Northern States Power Company
Prairie Island Nuclear Generating Plant
1717 Wakonade Dr. East
Welch, Minnesota 55089

PRAIRIE ISLAND NUCLEAR GENERATING PLANT
Docket Nos. 50-282 License Nos. DPR-42
50-306 DPR-60

Response to Request for Additional Information Related to the
Prairie Island Individual Plant Examination Report (TAC Nos. M74454 and M74455)

Detailed HRA Using Swain

HRA Event Tree for HRECIRCSMY

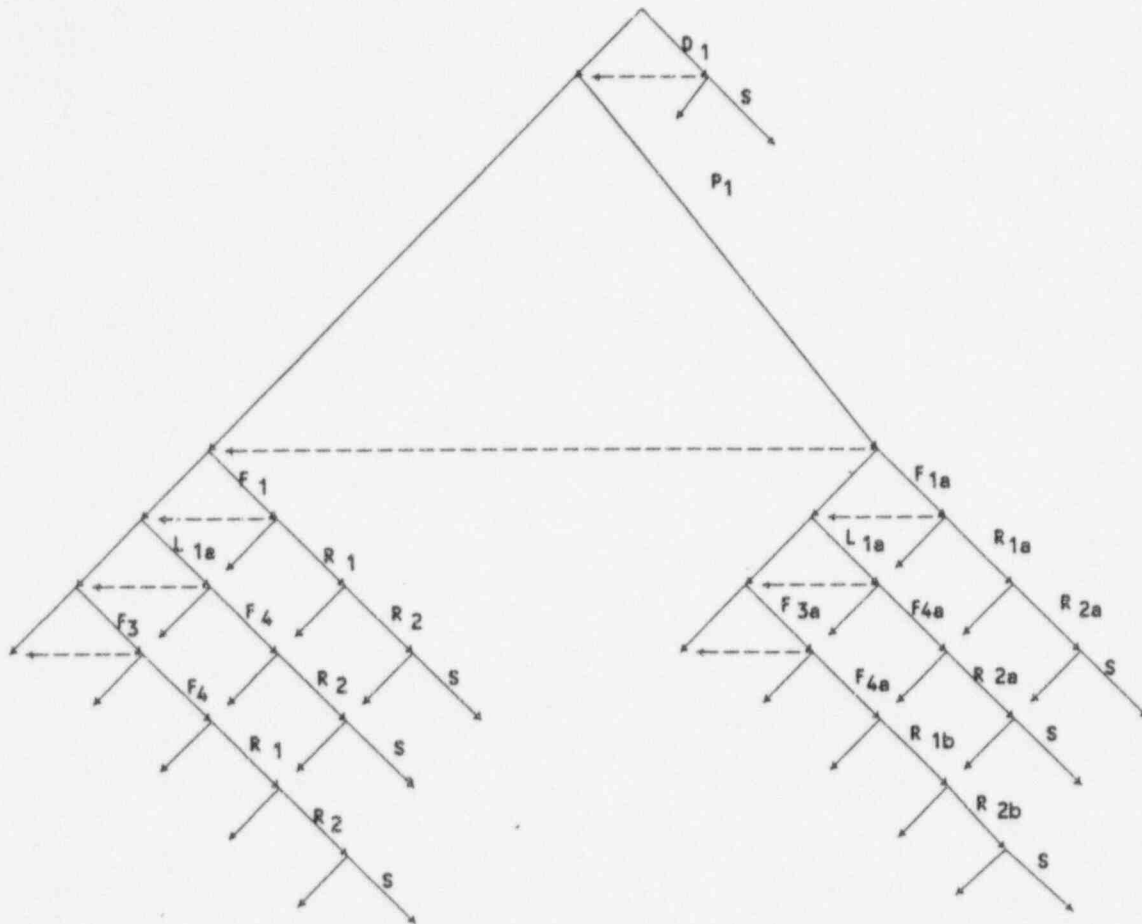
4.3 E-4 ← I come up with this value. This

is within the error band of the number used in the IPE and therefore the value used in the IPE is adequate.

Also, correct number is given in table 4-1 at the end of the calculation. The number used in IPE is based on table 4-1.

HRA Event Tree for HRECIRCXXY

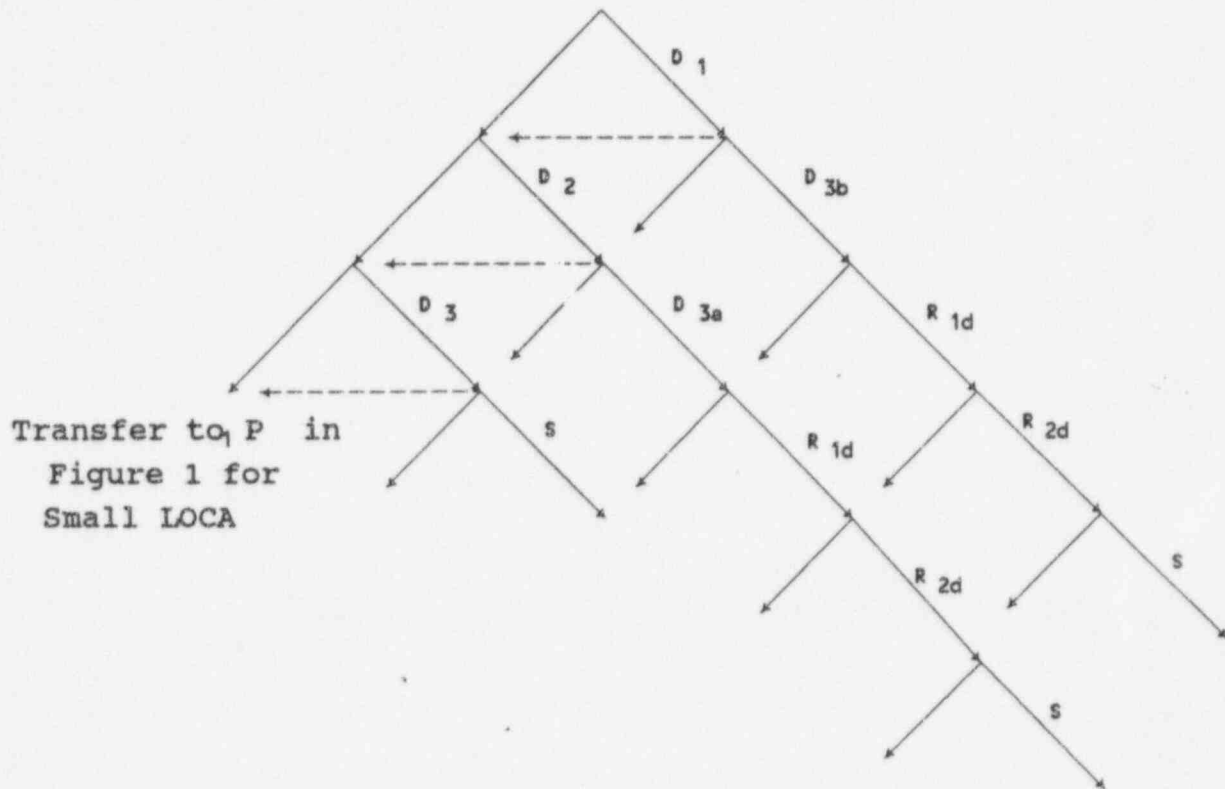
These times seem short compared to MPP008/92. Because less time is conservative I won't pursue it any further (33% = 2.7 hr, 50% = 3.03 hr)

should use 0.19 here Cbn 11-2-95

7.3 E-5 if .19 used instead of .15

*↑
should be
error factor
of 5.*
